- A0 TITLE SHEET
- A1 BASEMENT FLOOR ELEV. 'A' & 'B'
- A2 GROUND FLOOR ELEV. 'A'
- A3 SECOND FLOOR ELEV. 'A'
- A4 GROUND FLOOR ELEV. 'B'
- A5 SECOND FLOOR ELEV. 'B'
- A6 FRONT ELEVATION 'A'
ROOF PLAN ELEV 'A'
- A7 RIGHT SIDE ELEVATION 'A'
- A8 REAR ELEVATION 'A' & 'B'
- A9 LEFT SIDE ELEVATION 'A'
- A10 FRONT ELEVATION 'B'
ROOF PLAN ELEV 'B'
- A11 RIGHT SIDE ELEVATION 'B'
- A12 LEFT SIDE ELEVATION 'B'
- D1 CONSTRUCTION NOTES
- D2 CONSTRUCTION NOTES
- D3 CONSTRUCTION NOTES

APPROVED DRAWINGS HAVE BEEN RED LINED INDICATING A CHANGE TO MEET THE OBC. PLEASE REVIEW ALL PAGES TO ENSURE YOU ARE PROPERLY INFORMED OF CHANGES.

Tice River Homes

Legacy

BASEMENT FLOOR ELEV. 'A' & 'B'

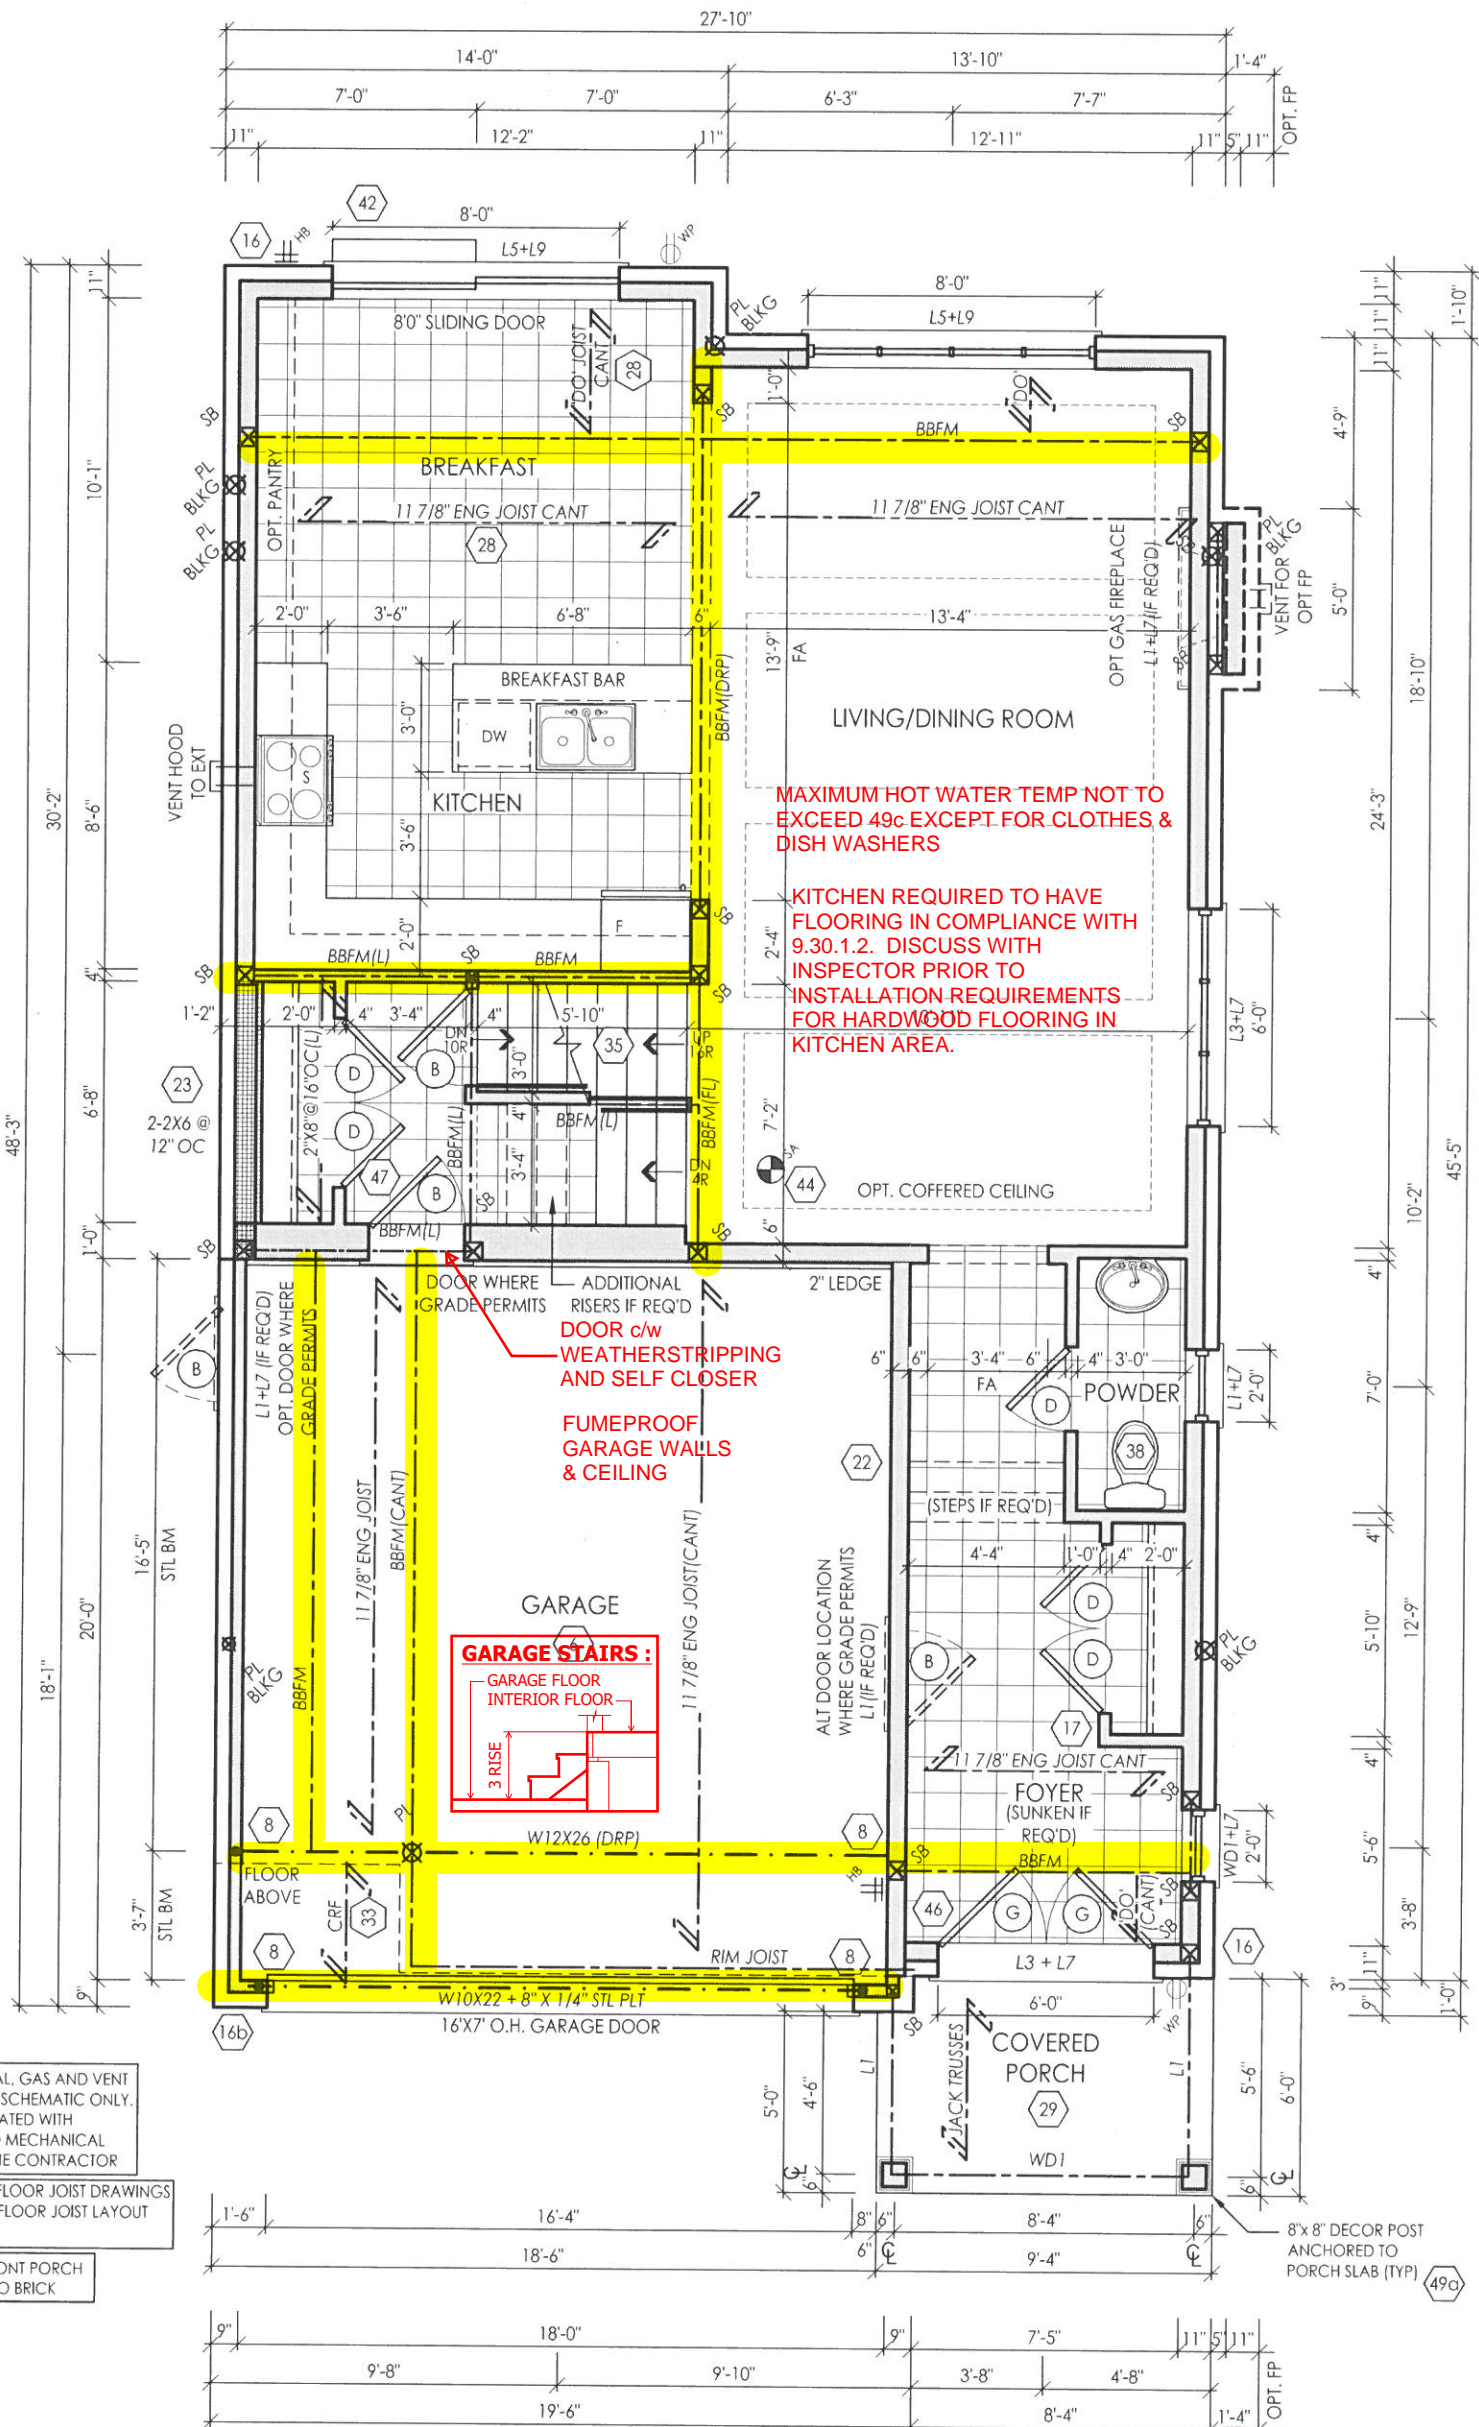
**BASEMENT AIR BARRIER
SUMP PUMP LIDS, JOINTS AT INTERSECTIONS & ALL
PENETRATIONS OF SLAB MUST BE SEALED TO
PREVENT AIR LEAKAGE.**

GROUND FLOOR ELEV. 'A'

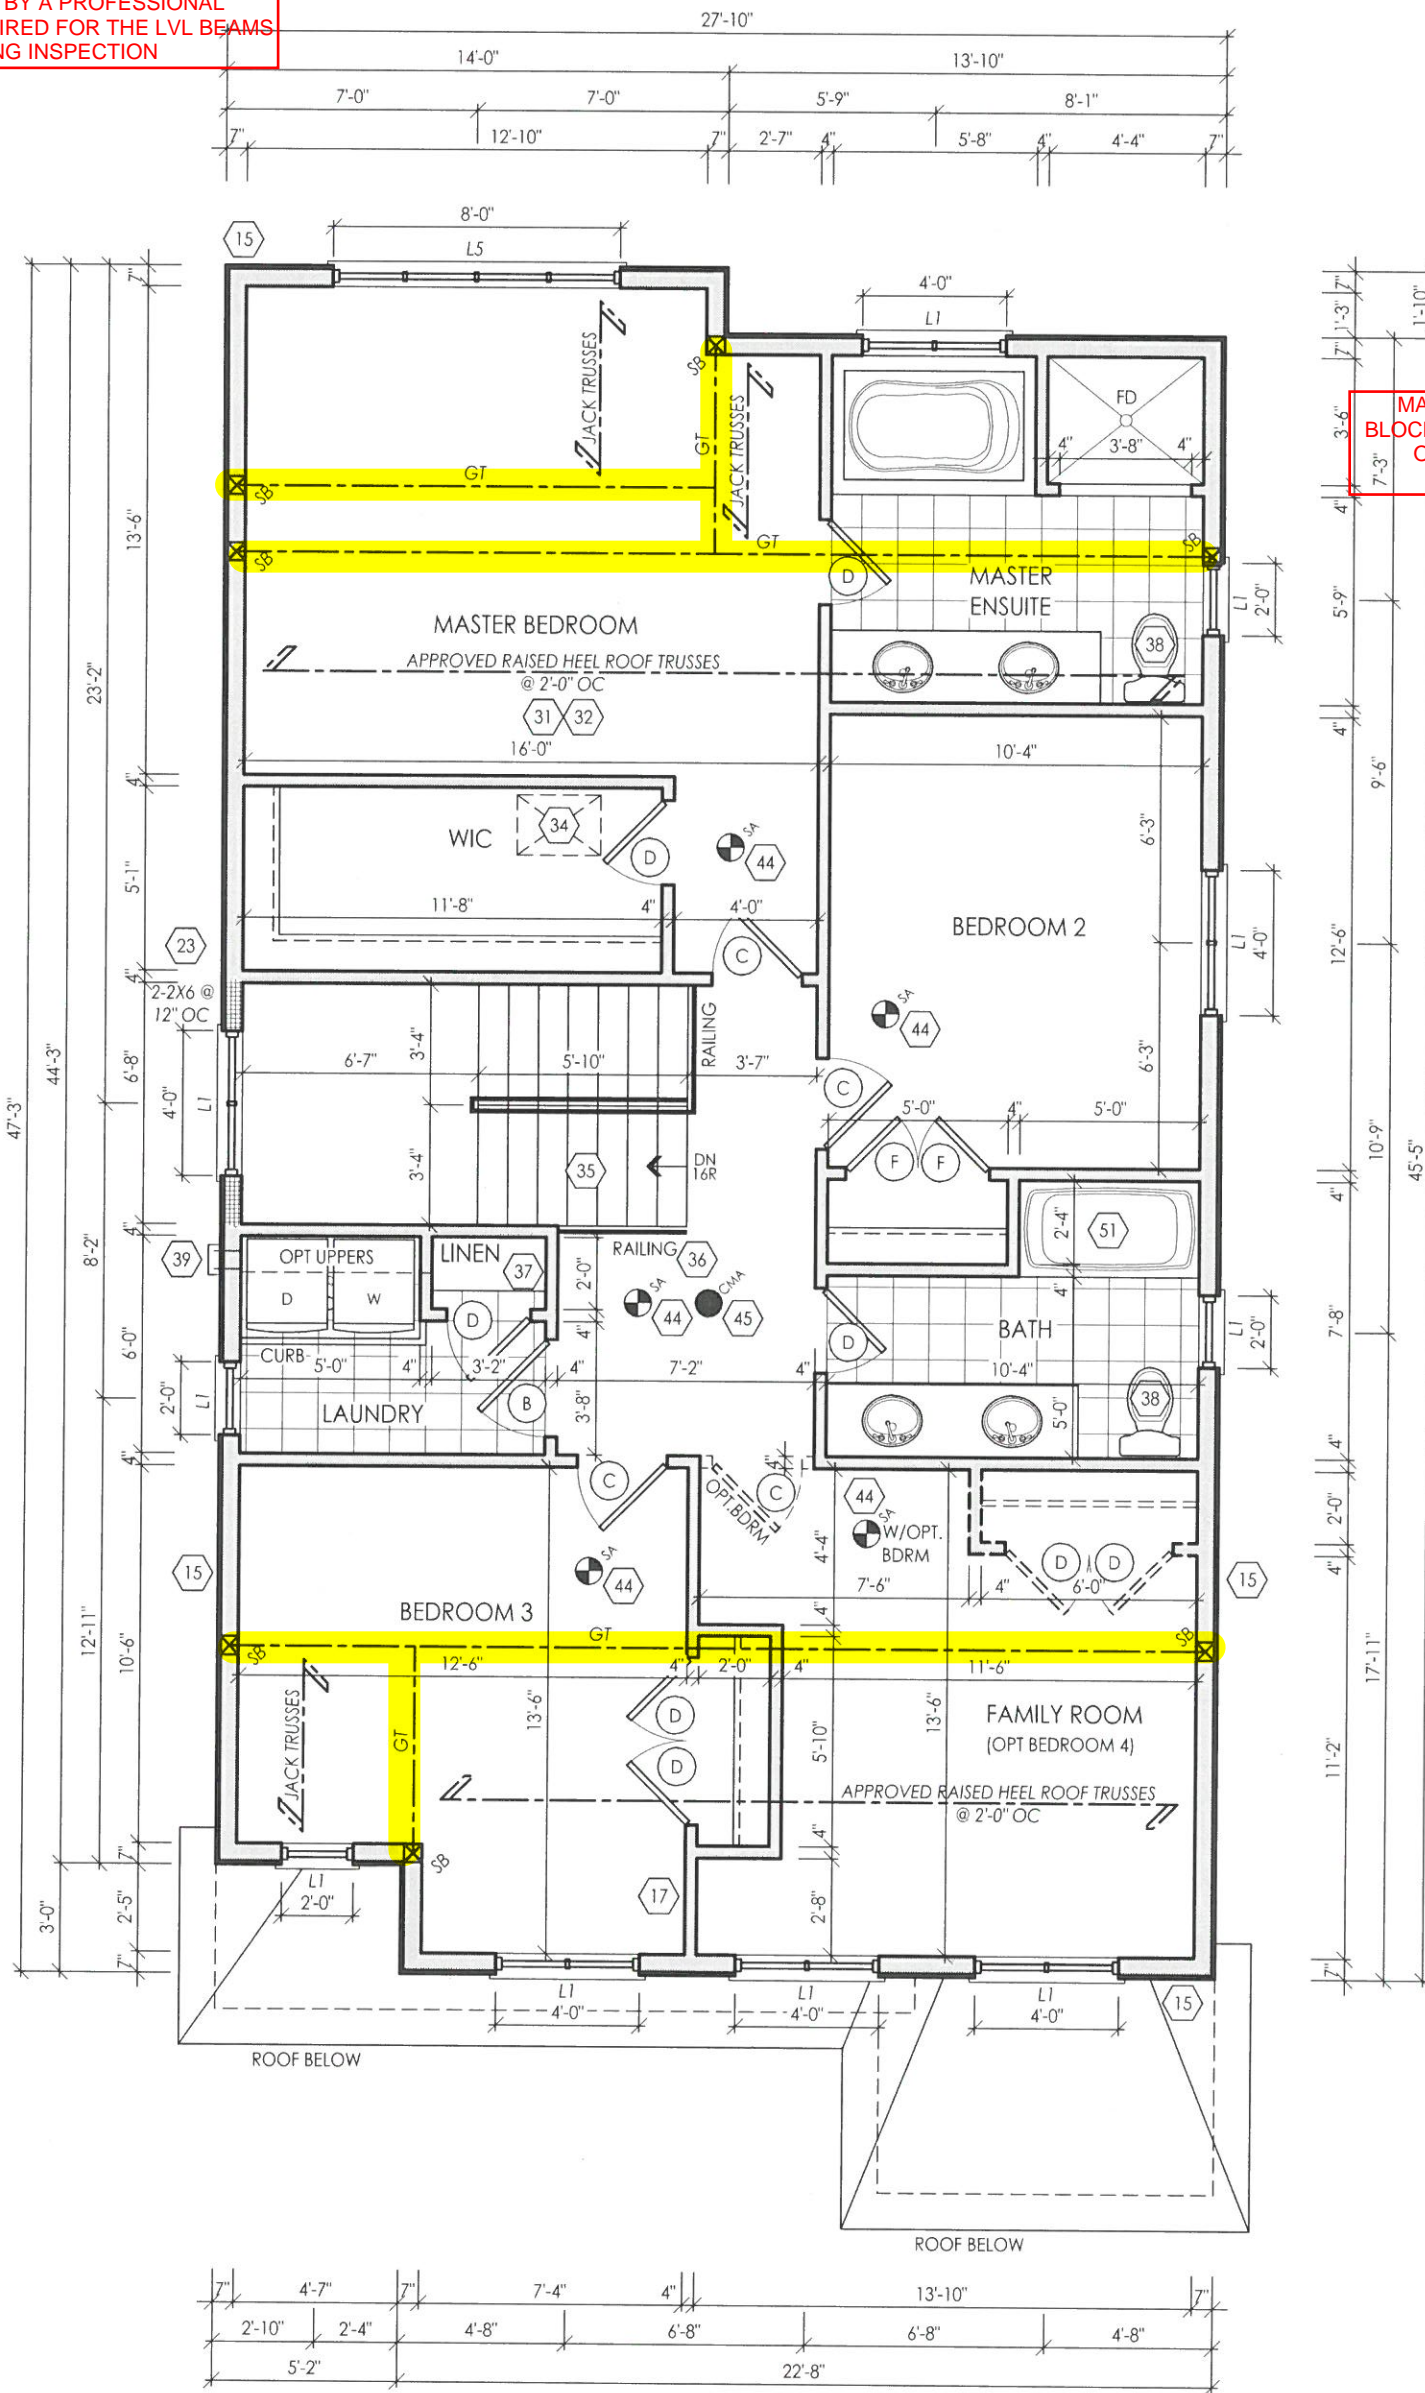
NOTE: CONC FRONT PORCH POURED PRIOR TO BRICK

SECOND FLOOR ELEV. 'A'

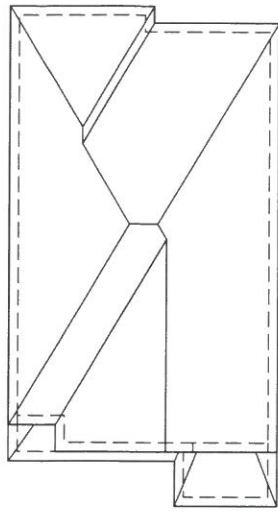
PROVIDE P.ENG APPROVED TRUSS & FLOOR DRAWINGS AND SPECIFICATIONS TO BUILDING INSPECTOR AT FRAMING INSPECTION.

A SMOKE ALARM SHALL BE INSTALLED ON EACH FLOOR LEVEL AND WITHIN EACH SLEEPING ROOM. ALL SMOKE ALARMS SHALL BE INTERCONNECTED. EACH DEVICE SHALL HAVE A VISUAL SIGNALING COMPONENT IN ADDITION TO THE TEMPORAL PATTERN IN CONFORMANCE WITH 18.5.3. OF OF NFPA 72.

DETAILS SEALED BY A PROFESSIONAL ENGINEER ARE REQUIRED FOR THE LVL BEAMS ON FRAMING INSPECTION

A CARBON MONOXIDE DETECTOR SHALL BE LOCATED ADJACENT TO SLEEPING AREAS

MAIN BATHROOM TO HAVE STUD BLOCKING FOR FUTURE INSTALLATION OF GRAB BARS ADJACENT TO SHOWER/TUB AND TOILET.

page A8

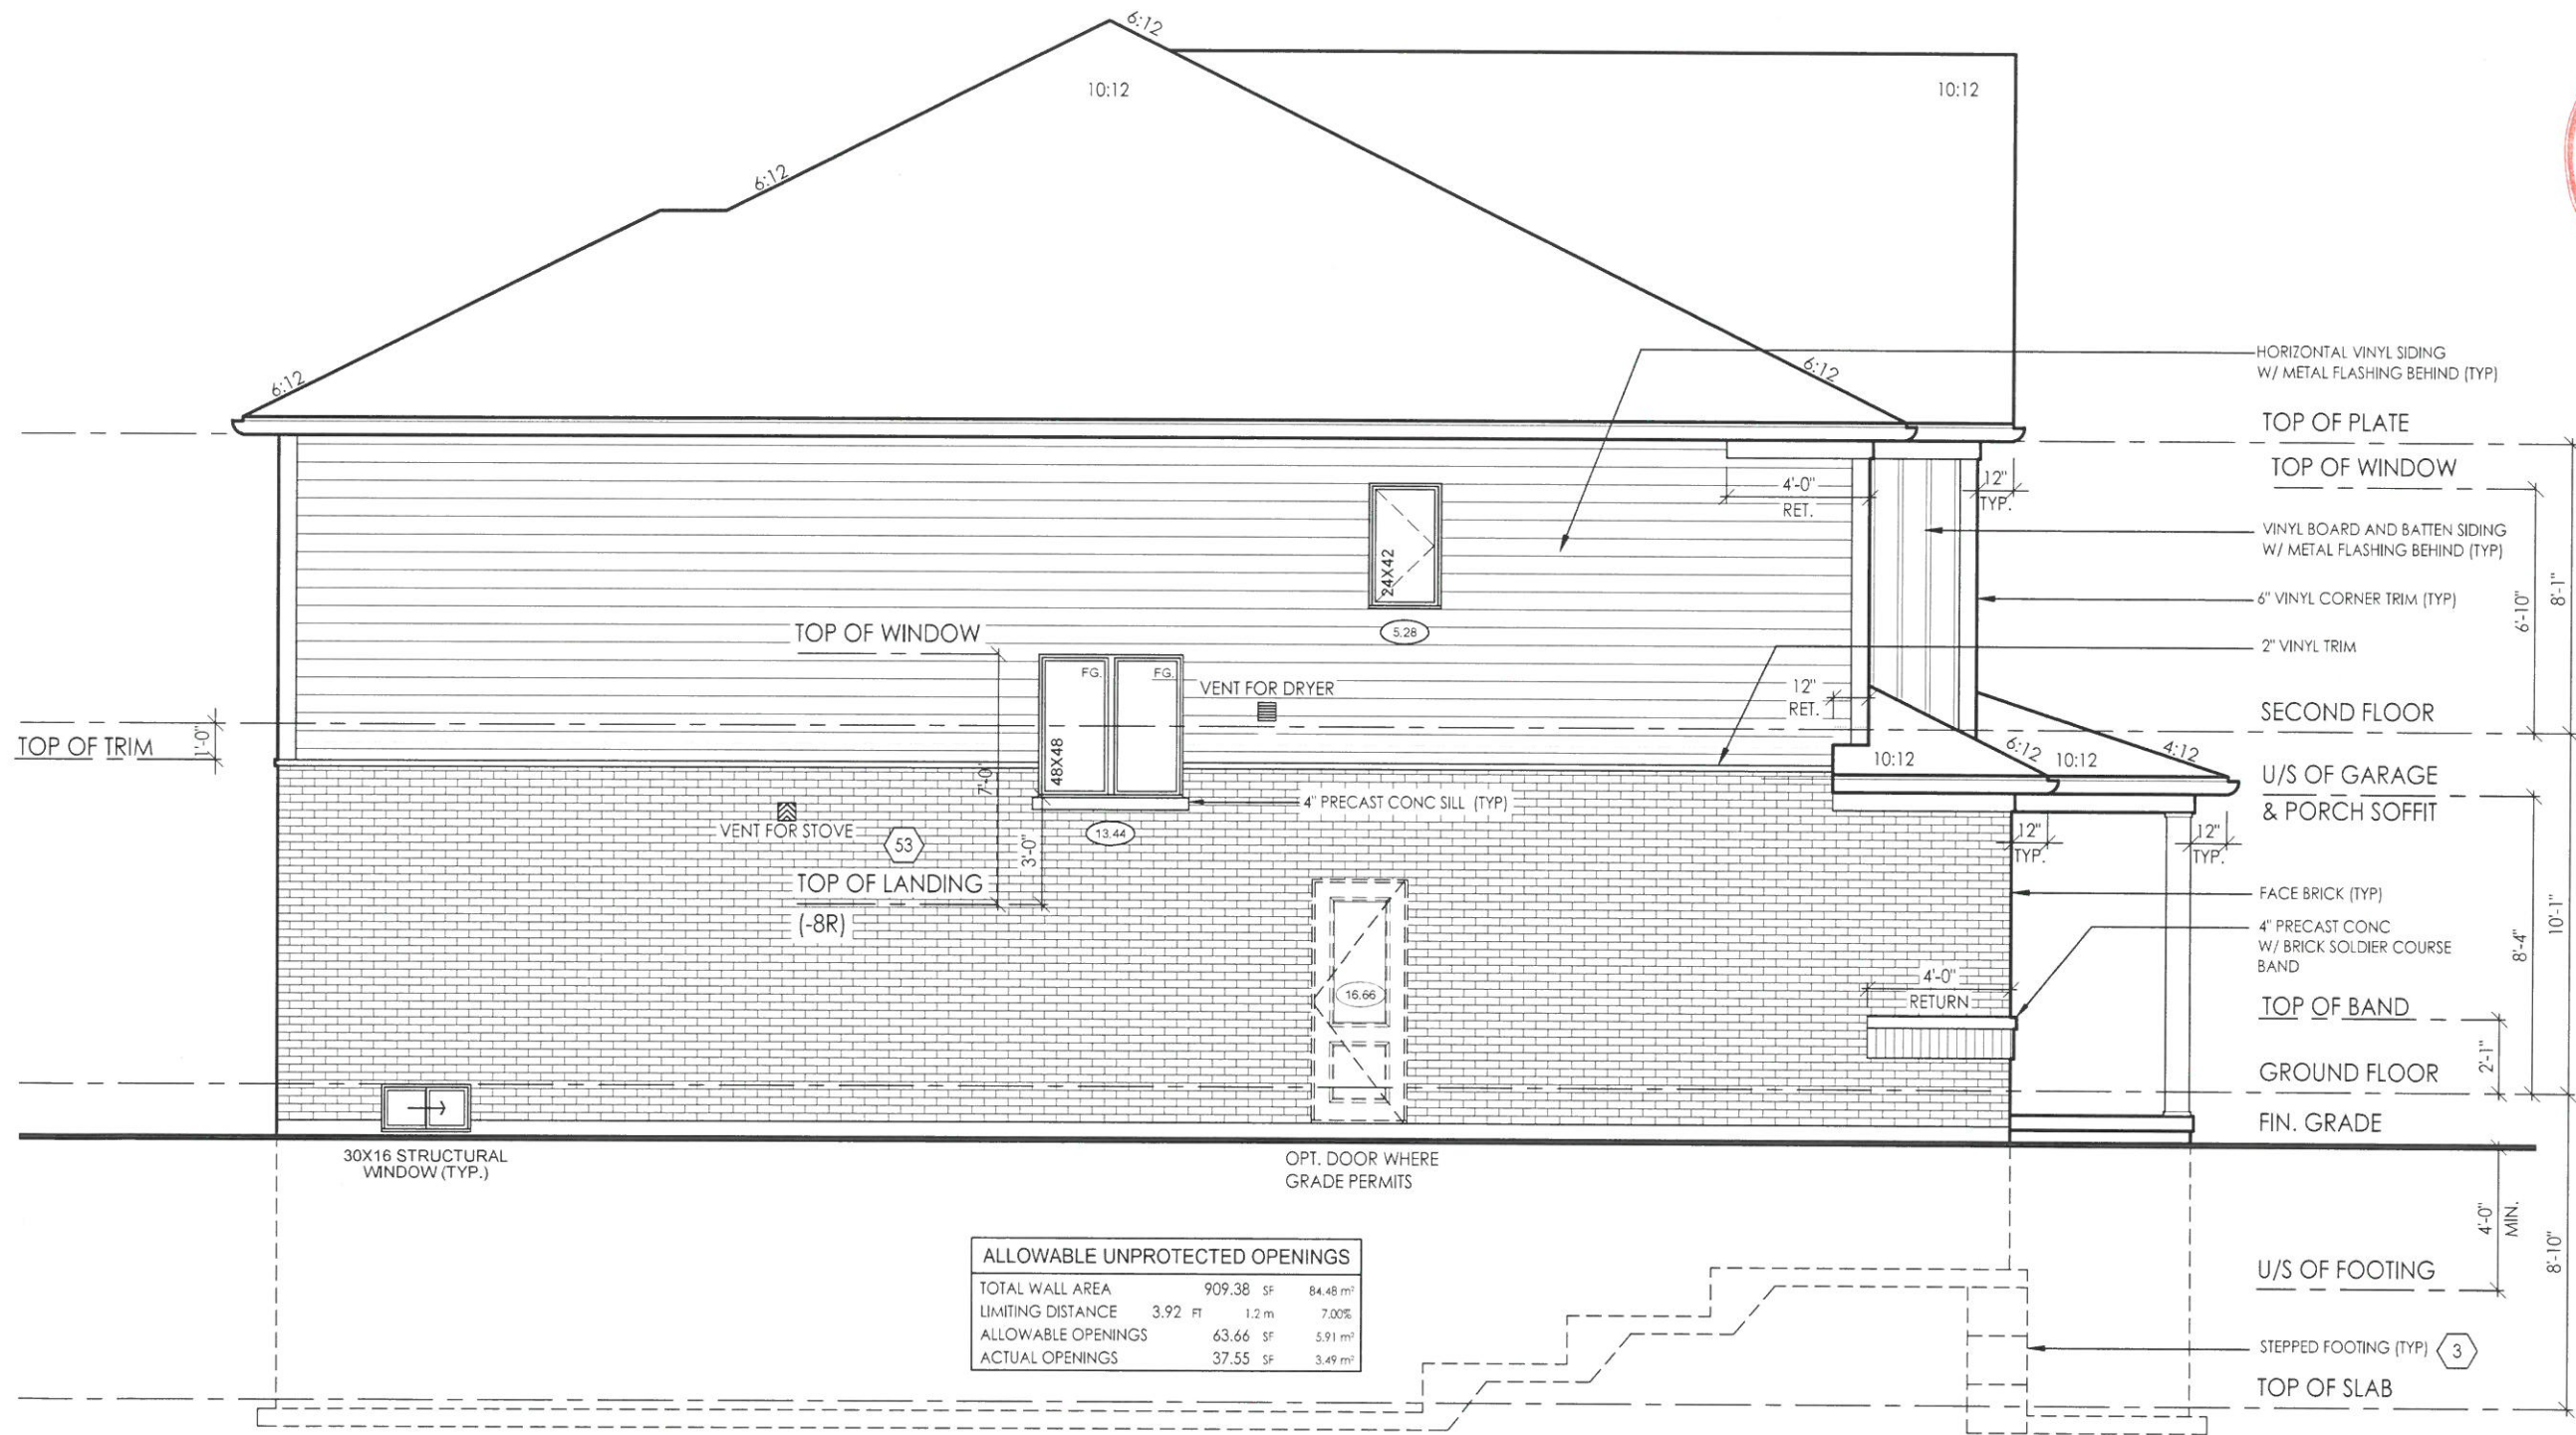
GUARDS CONFORMING TO O.B.C. 9.8.8. & SB-7 ARE REQUIRED FOR PORCHES EXCEEDING 24" ABOVE GRADE.

MAX. 3 RISERS TO OMIT LANDING AT TOP OF STAIRS
